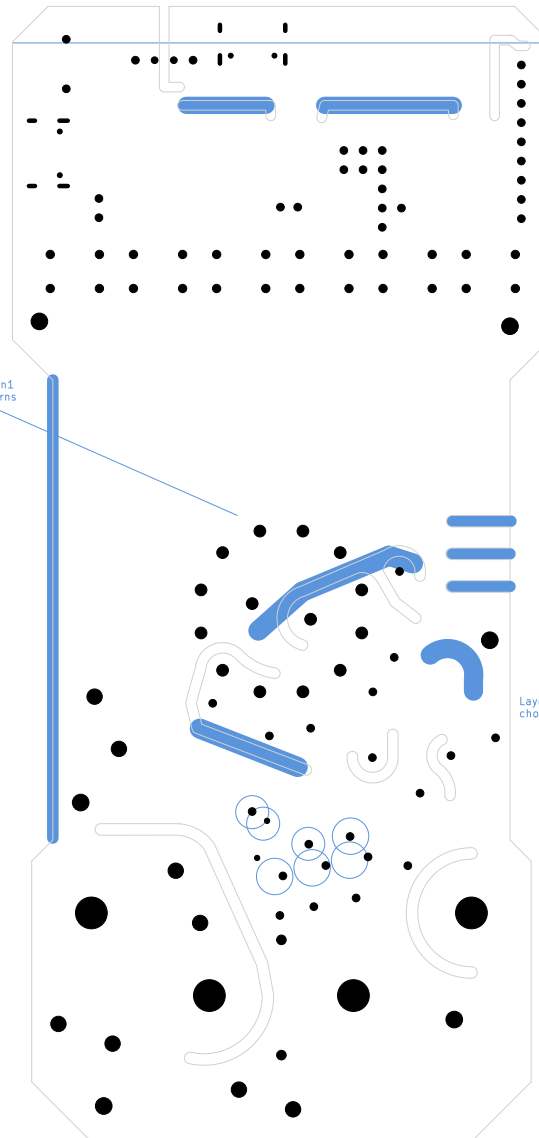
Intentionally NOT connected on In1
separate digital and analog returns

Layers and removed pad layers
chosen to increase clearance
